1 SPRING STREET, MELBOURNE

RESPONSE TO REQUEST FOR FURTHER INFORMATION

Permit application P41783

September 2026

Figure 1 Permit P33300 - detail from demolition plan Level 1 showing the relocation of the glass block wall
Source: Ingenhoven + Architectus and Seidler, 1 Spring Street & 17 Flinders Lane, drawing no. DA9705 revision L

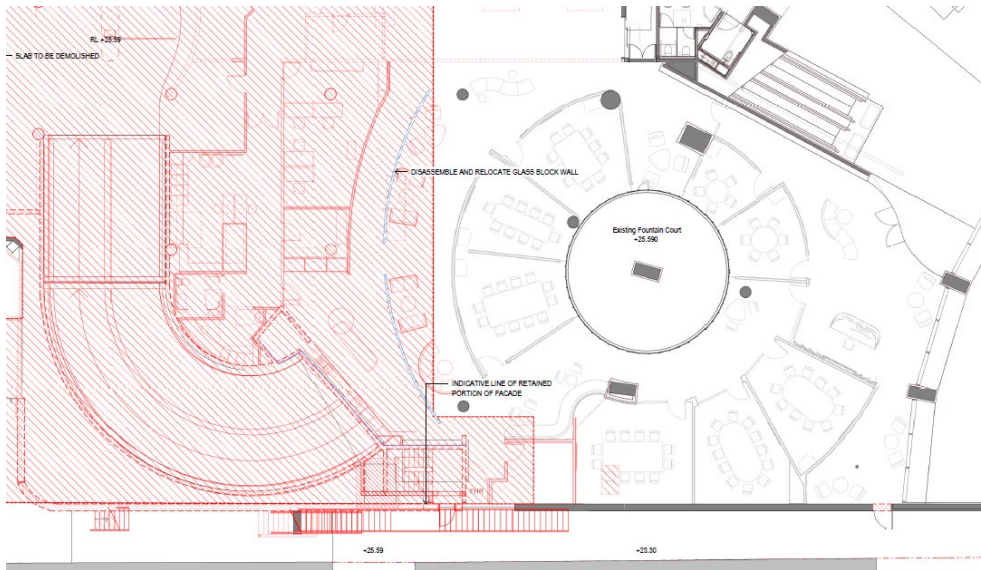
However, the proposed Level 1 floorplan does not identify the curved glass block screens that formed part of the original cafeteria design and have been retained in situ. These screens are considered significant features that contribute to the understanding of the original spatial arrangement of the space. Please provide further information regarding the proposed treatment of the screens.

No change is proposed to the glass block screens in the 'fountain court' space on Level 1 as part of this application.

To clarify, the works approved under Heritage Permit P33300 (issued on 17 May 2024) included the relocation of the glass block screens slightly to the south to accommodate a waste room and amenities to the north. The change was addressed in the Heritage Impact Statement for permit application P33300 and is shown on drawings approved by Heritage Victoria under Condition 1 on that permit (see Figure 1, Figure 2 below).¹

Figure 5 Plan and section showing the detail of the sliding door
Source: HSA, HV-101A Typical Floor Section: Detail Sections

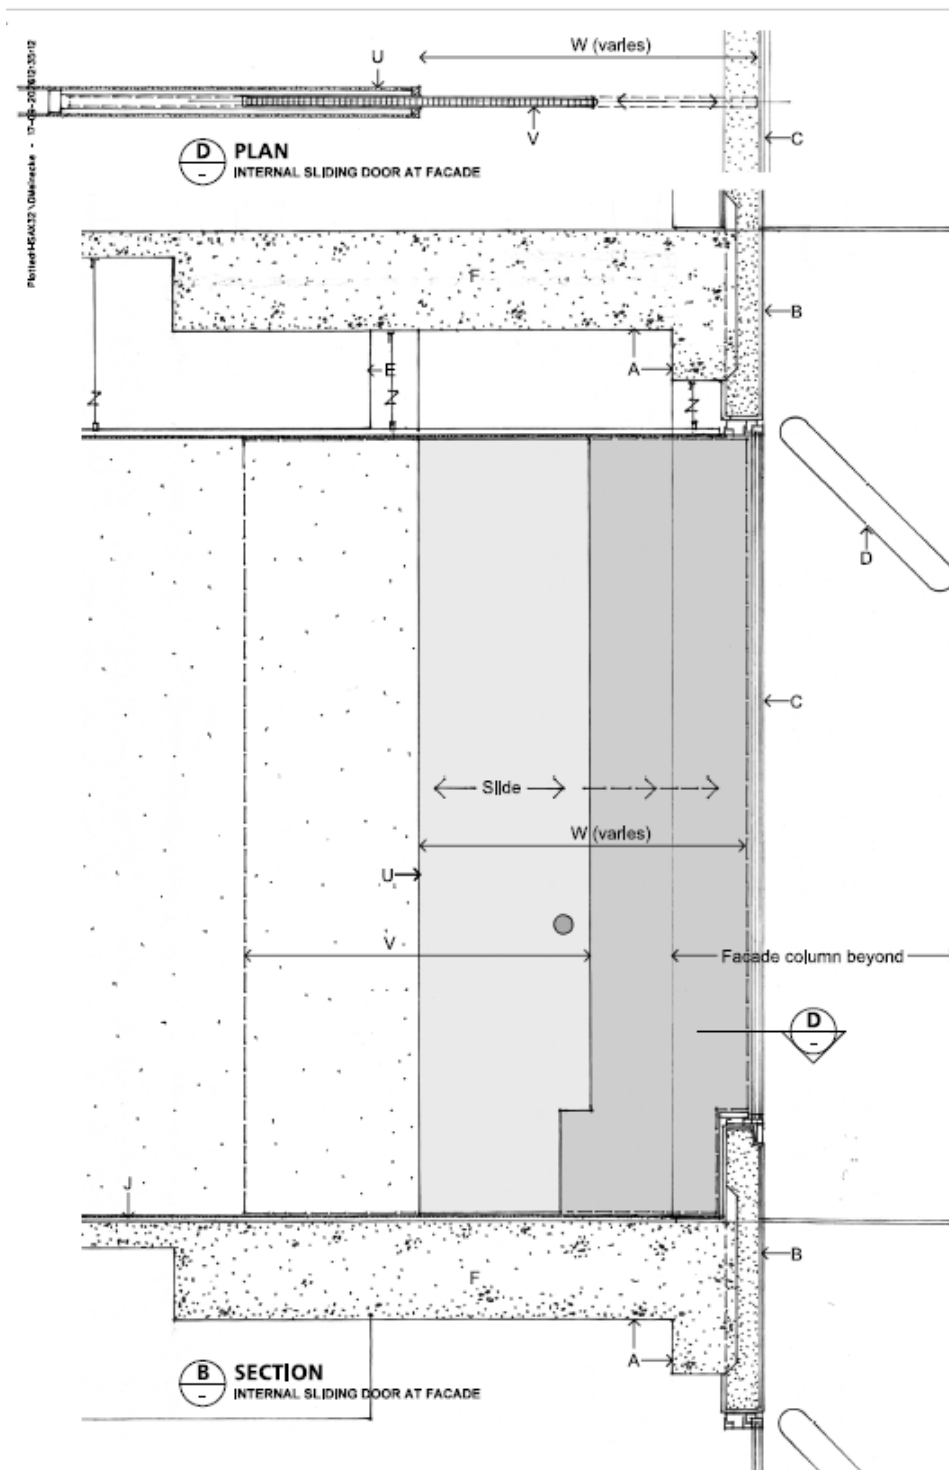
The HIS and architectural drawings indicate that a number of proposed internal partition walls will not align with the existing column grid or façade mullions and will instead terminate directly against the window glazing.

Further information is required to explain the rationale for this approach and to demonstrate why it represents the preferred design outcome.

Given the significance of the building's curtain wall façade, it would generally be expected that apartment layouts and partition arrangements would be refined to avoid direct intersections with glazing and to prevent awkward or visually intrusive junctions.

This issue is referenced in the revised Heritage Impact Statement at pp. 37-38. To clarify, the internal wall does not abut or terminate at the glazing but sits back from the façade. Rather, an internal sliding door accommodated in the wall cavity comes forward towards the glazing. The sliding door has been designed to interface lightly with the glazing and is very narrow in plan with a neoprene edge seal detail to the end for protection. The door has also been designed with a corner cutout to accommodate the granite sill, i.e. the door would slide over the sill. There would be no physical fixing to the glazing, framing or granite sill, nor would there be a visual impact to the external presentation of the building.

An additional drawing has been prepared by HSA to further clarify the nature of this detail, HV -101A Typical Floor Section: Detail Sections (refer to Figure 5 below). This should be read in conjunction with the detail at drawing HV-111B Construction Details 02 which shows the internal sliding door in plan over the sill and details the seal (see Figure 6).

As noted above, an additional drawing (plan and section) has been prepared to clarify and demonstrate the design detail (see Figure 5), HV -101A Typical Floor Section: Detail Sections. This has been included in both the architectural drawing pack and the Architect's Design Analysis (Attachment 1). The detail is explained at section 3.3.2 (pp. 37-38) of the revised Heritage Impact Statement.

Figure 7 Varied window configurations on the south-east elevation (levels 4-14)
Source: HSA, HV – 160A Tower South-east Developed Elevation, Typical Window

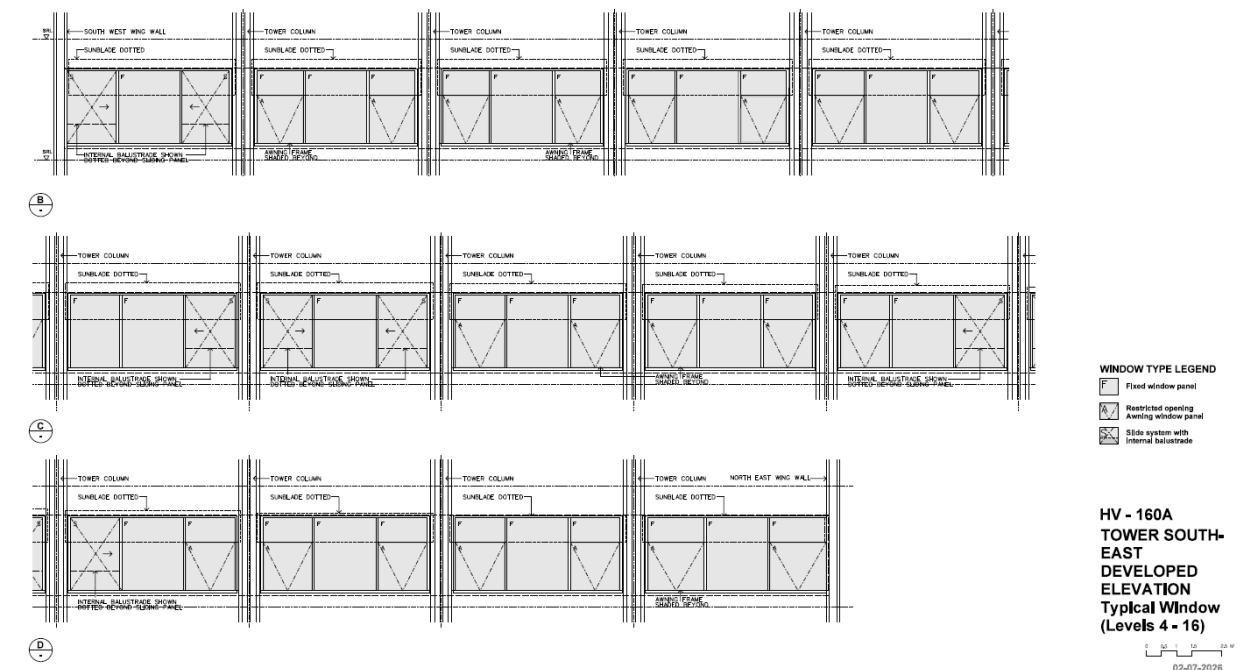
Further detail is required regarding the proposed loggias. As loggias are typically open-air spaces, it is assumed that their introduction would require alterations beyond the replacement of glazing shown on the submitted drawings. Clarification is therefore required regarding the design of the proposed loggias, including:

- *Whether the spaces are intended to be open to the elements,*
- *The extent of any façade modifications required, and*
- *The resulting impact on the external appearance and heritage significance of the building.*

For all windows (whether to loggias or not), there is always a fixed window panel (the central panel in the tripartite arrangement) with operable windows to both sides, either Window Type 01 (awning detail) or Window Type 02 (sliding panels with internal glazed balustrade behind). As noted in the Architect's Design Analysis (Attachment 1), all window units will maintain the tripartite arrangement and the use of the bronze tinted glazing and black anodised aluminium framing in dimension and proportion. The sunblades in front of the windows remain in place.

- Window Type 02 (sliding panel with internal glass balustrade behind) to both sides of the central fixed panel
- or
- Window Type 01 (awning) to one side of the central fixed glazed panel and Window Type 02 (sliding panel with internal glass balustrade behind) to the other.

The variations of sliding and awning window types in combination with the fixed central glazing panels are indicated on the elevations (see Figure 7 for example) and illustrated in the visualisations in the Architect's Design Analysis report (Attachment 1) submitted with the application.
